Appendix I of RNTPC
Paper No. A/YL-ST/606

Proposed Temporary Public Vehicle Park for Private Car for a Period of 3 Years
at
Lots 3045 RP, 3056 RP in D.D. 102 & Adjoining Government Land, San Tin, Yuen Long, N.T.

I refer to the captioned s.16 application. Please see the attached departmental comments received for your response:

Proposed Temporary Public Vehicle Park for Private Car for a Period of 3 Years at Lots 3045 RP, 3056 RP in D.D. 102 & Adjoining Government Land, San Tin, Yuen Long, N.T.

Proposed Layout Plan

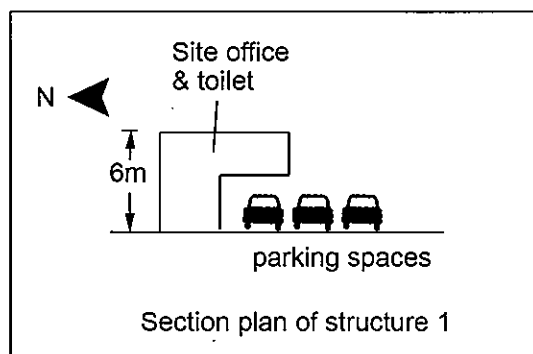
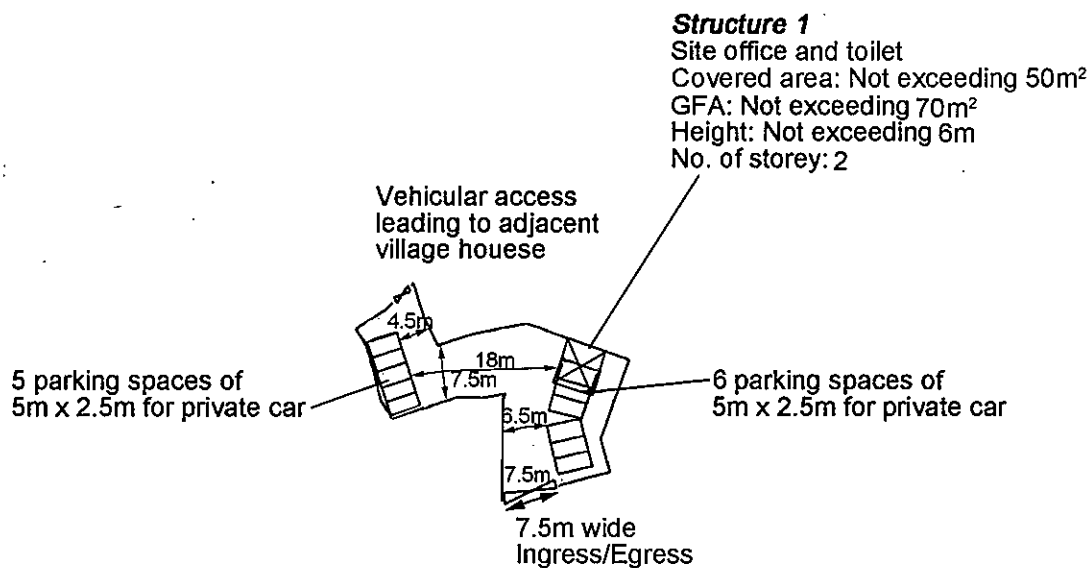
(c) The applicant should demonstrate sufficient space for manoeuvring of the type of vehicle allowed within the subject site.	Noted. The proposed layout in Figure 3 is the same as the previous planning permission No. A/YL-ST/537 approved in early 2019 which demonstrated that there is sufficient space for manoeuvring of the private car within the application site. The applicant is also glad to submit an updated layout plan to show the dimensions of the manoeuvring space within the application site.
